1 ***EXHIBIT 2 – RATE BASE AND DISTRIBUTION SYSTEM PLAN***

2
3 ***Interrogatory 2-Staff-10***

EXHIBIT 2 – RATE BASE AND DISTRIBUTION SYSTEM PLAN

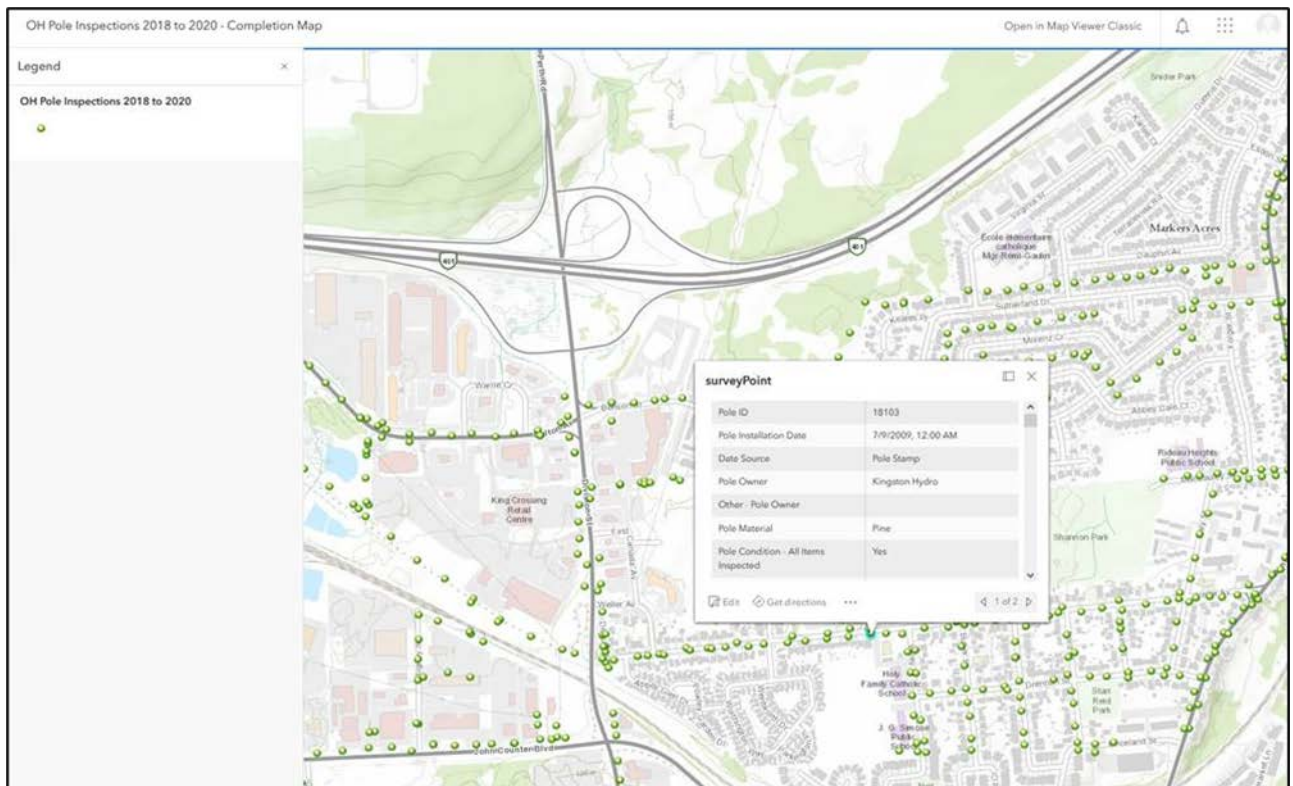
a) Please provide an example of real-time dashboard information as accessed by staff from the GIS.

Response

a) Our Power Line Technicians and Substation Electricians act as inspectors to collect information during their infrastructure inspections via the ArcGIS Collector app and ArcGIS Survey123 app. Depending on the type of inspection (pole, manhole, transformer vault, substation) the app has predetermined parameters to choose from, some of which have a grading system (where applicable). For example, does the pole have shell rot (yes or no)? If yes, what is the severity of shell rot (Minor,

Figure 5.2-18 – 2015 to 2021 System Reliability Indices 2 Excluding Loss of Supply and Major Event Days

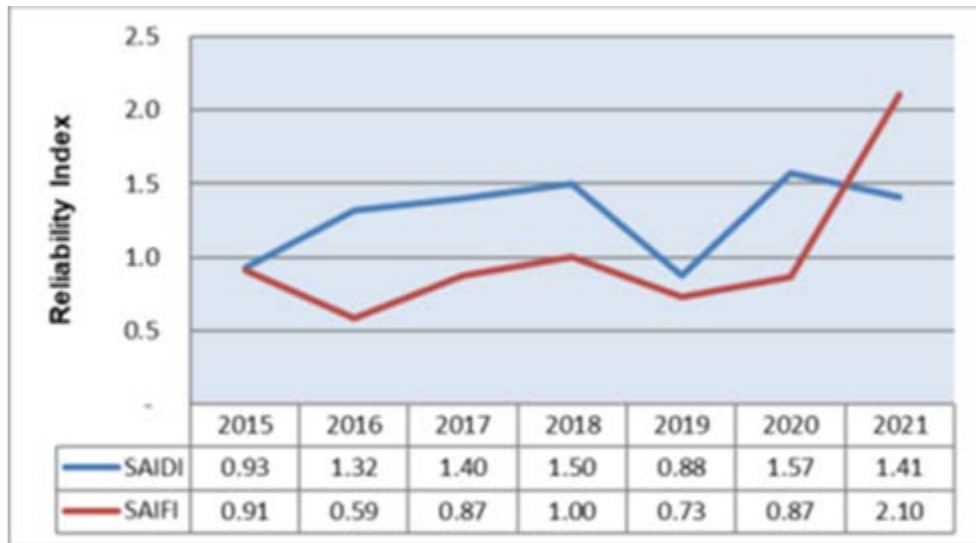
Reference: Exhibit 2, Tab 4 DSP, page 65-

“• 44kV Customer-owned Equipment Failure in 2021
